**AMENDMENTS TO THE DRAWINGS**

**REMARKS/ARGUMENTS**

FIG. 2

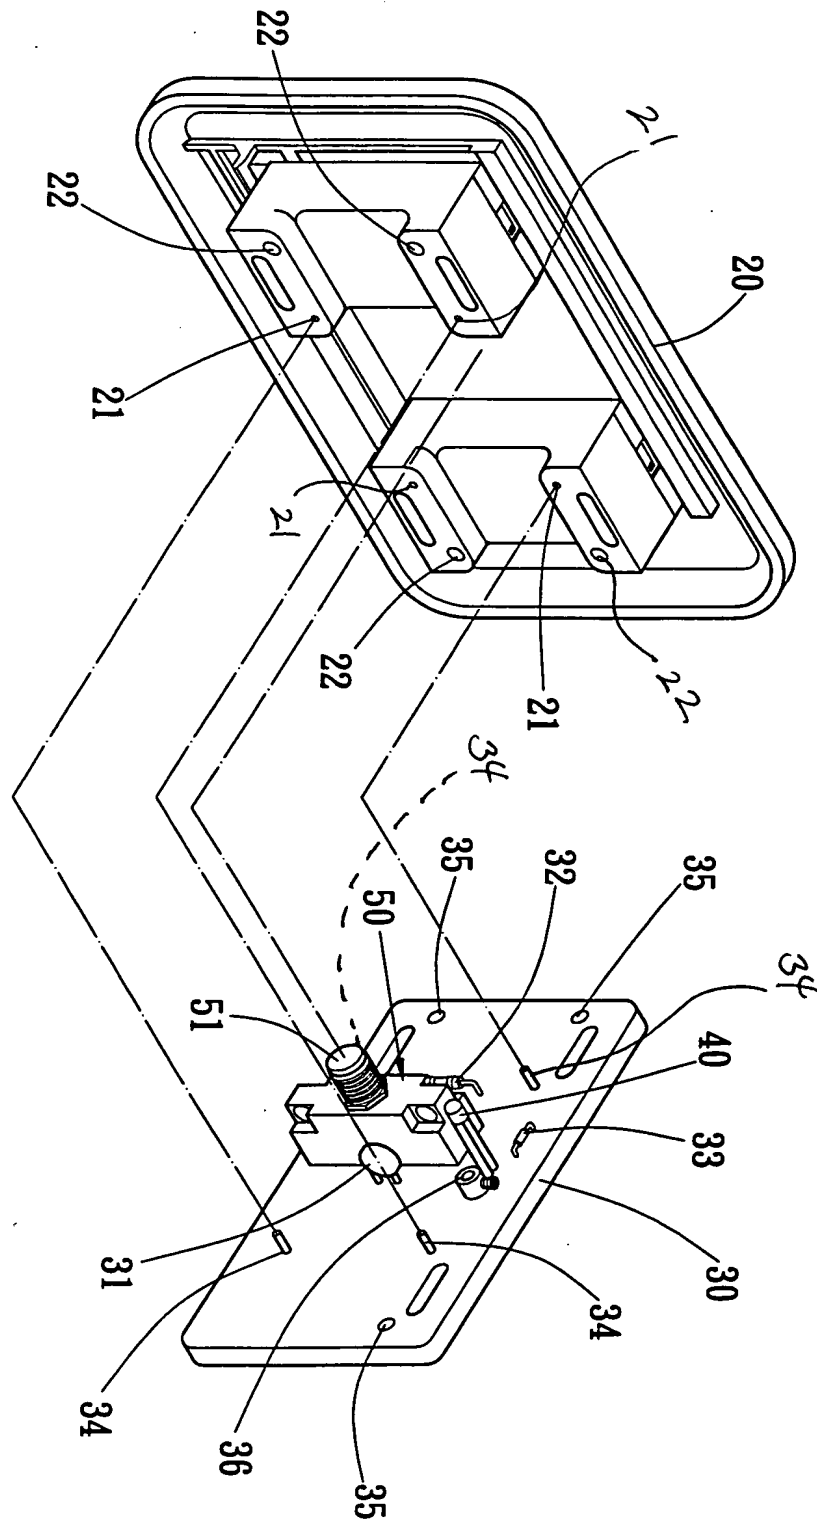
The attached sheets of Drawings include changes to Figs. 2-5. These sheets, which include Figs. 2-5, replace the original sheets including those Figures. In each of the Figs. 2-5, certain reference characters are more clearly and more fully noted for the various portions of certain elements they denote.

Certain of the Drawings as originally filed are hereby amended to more clearly and correctly indicate the various disclosed elements by their corresponding reference characters. Such clearer notation of the reference characters removes the apparent confusion encountered by the Examiner in correlating, for instance, the circuit diagram of Figs. 3 and 4 with the structural views shown in Figs. 2 and 5.

The corrections to the Drawings specifically include, among other things, notation of the conductive portions of the circuit schematic diagrams illustrated in Figs. 3-4 which correspond to the plurality of insertion holes 21 and insertion rods 34 represented in Figs. 2 and 5. The Drawings corrections also include notation of the reference characters 60, 60' appropriately at the input terminals labeled “AC in” in the circuit schematics of Figs. 3-4, making clear that these input terminals were properly labeled (as the Examiner had surmised that these terminals should have been labeled “AC out”). In addition, the output terminal incorrectly noted by the reference character “36” is now corrected to be noted by the correct reference character “22.”
